SERVICE BULLETIN

MITSUBISHI MOTORS

PURPOSE : CORRECTION	ISSUE NO. : MSB-15EXML51-501	DATE : 2015-12-01
SUBJECT : Error in writing of the adjustment of the jet type washer nozzle injection position		<DESTINATION/MODEL> As per attached sheet 1 <M/Y> 13-16
GROUP : Gr:51(Exterior)		OUTLANDER(GF0W)/ OUTLANDER PHEV(GG0W)

ACC00351AD

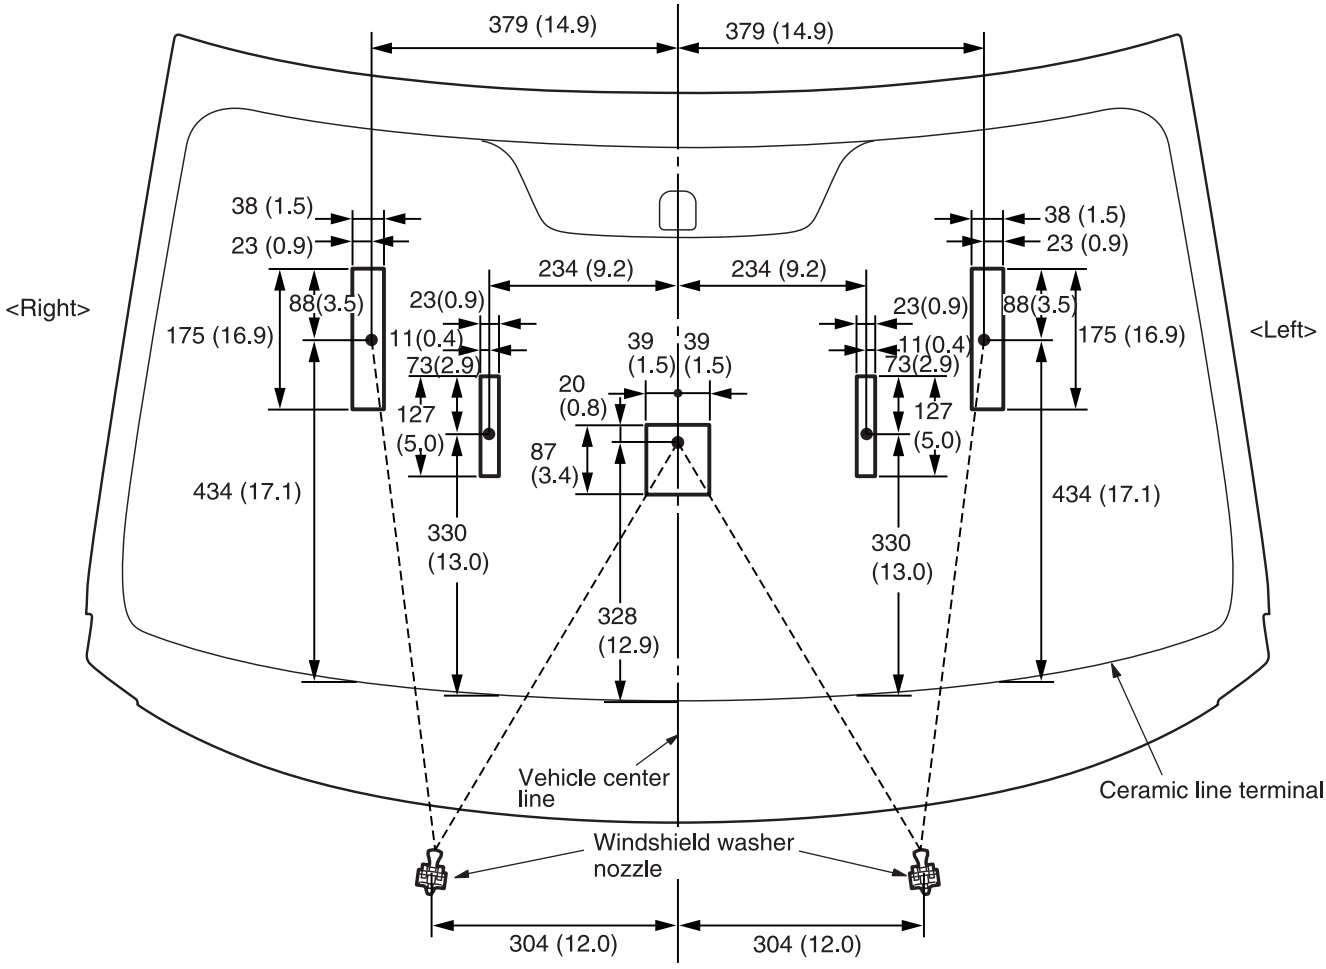
<Incorrect>

~~Replace the washer nozzle if it does not spray washer fluid onto the shown area.~~

<Correct>

1. Check whether washer fluid is sprayed as shown.

⚠ CAUTION

Be careful not to break a pin inside the washer nozzle when you adjust it.

2. If the spray pattern shown is not satisfied, use a pin (thinner than 0.7 mm in diameter) to adjust the washer nozzle.
